JOINT REGIONAL PLANNING PANEL (Hunter and Central Coast)

Council Assessment Report

Panel Reference	Panel Reference No. 2017HCC025
DA Number	52629/2017
Local Government Area	Central Coast Council
Proposed Development	Educational Establishment
Street Address	LOT: 12 DP: 589255, LOT: 11 DP: 589255, LOT: 2 DP: 545060, 9 Lea Avenue WAMBERAL, 5 Lea Avenue WAMBERAL, 11 Lea Avenue WAMBERAL
Applicant	EJE Architecture
Owner	Wamberal Public School
Date of DA Lodgement	10/08/2017
Number of Submissions	Four (4)
Recommendation	Approval - subject to conditions
Regional Development Criteria - Schedule 7 of the State Environment Planning Policy (State and Regional Development) 2011	Development carried out by or on behalf of the Crown with a capital investment value over \$5m
List of all relevant 4.15(1)(a) matters	<ul style="list-style-type: none"> • <i>Environmental Planning & Assessment Act 1979 – section 4.15 (EP&A Act)</i> • <i>Roads Act 1993 (Roads Act)</i> • <i>Rural Fires Act 1997 (RF Act)</i> • <i>Water Management Act 2000 (WM Act)</i> • <i>Water Management (General) Regulation 2011 (WMG Regulation)</i> • <i>State Environmental Planning Policy No 71 – Coastal Protection (SEPP 71)</i> • <i

**Figure 8 – Extract from Tree Management Plan –
New landscaping buffer and building setback to boundary**

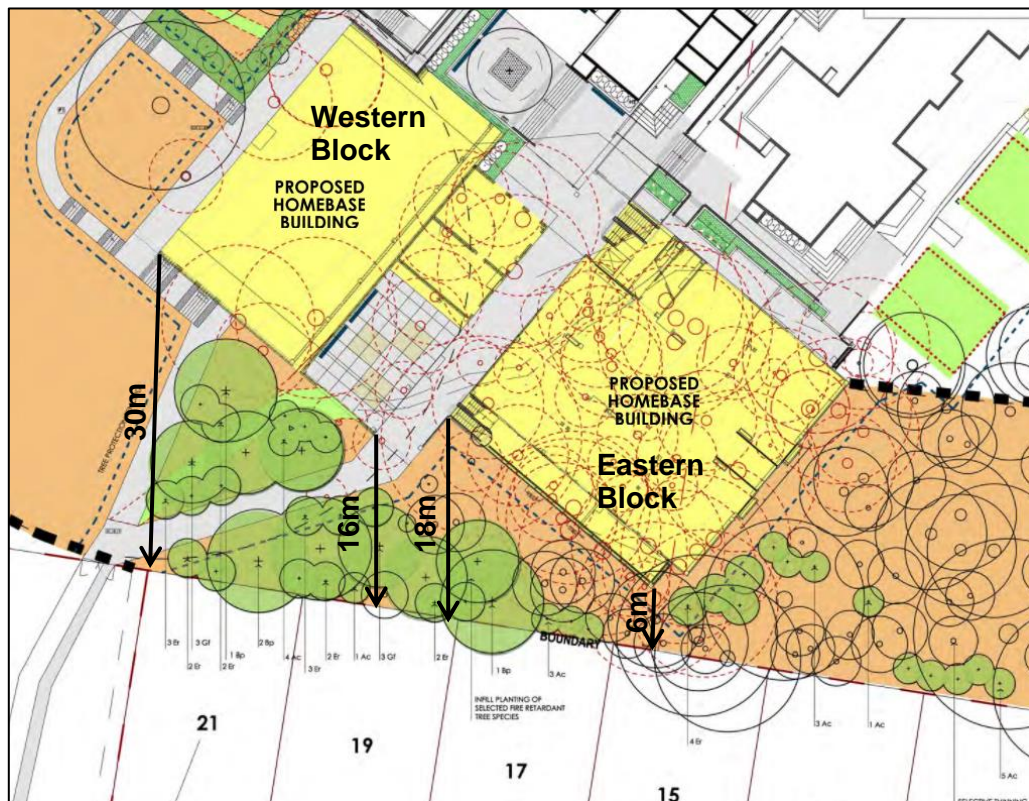
Objection was raised by adjoining neighbours regarding the siting of the building and its impact on their amenity. Council requested the Applicant to consider alternative locations for the building to the east or west of the existing school buildings or provide further justification for the selected location to substantiate the level of tree removal and address neighbours' concerns.

The building setback to the residential properties is variable from 6m to 18m (eastern block) and 16m to 30m (western block) as shown in Figure 8 below. The inclusion of the additional landscaping buffer to supplement the existing trees to be retained within this building setback area is substantial and supported as an acceptable solution to address privacy impacts and reduce the bulk and scale of the new two storey building.

Visual privacy is addressed by the proposed landscaping buffer using selected trees which will provide a mid-level canopy between the proposed building and the boundary as shown in the Tree Management Plan extract in Figure 8.

The Applicant proposes an additional in-fill landscaping buffer of screening plants between the building and the adjoining neighbours to improve privacy and amenity to adjoining neighbours. The landscaped screening buffer is identified on the amended Tree Management Plan, prepared by Terras Landscape Architects, dated 13 March 2018, as shown in the extract of the plan at Figure 8.

The selected trees comprise plant species found in the area and will provide a mid-level canopy between the proposed building and the boundary. The tree planting proposes advanced specimens (100ltr pot size). Plants are expected to be at least 4m high when planted and achieve up to 10m high at maturity. The extent of the tree removal required for the location of the Homebase building is offset by the proposed new plantings (a total of 45 trees are to be planted in accordance with the Tree Management Plan). The view to the neighbours depicted by Figure 7 will be improved by the proposed tree planting.
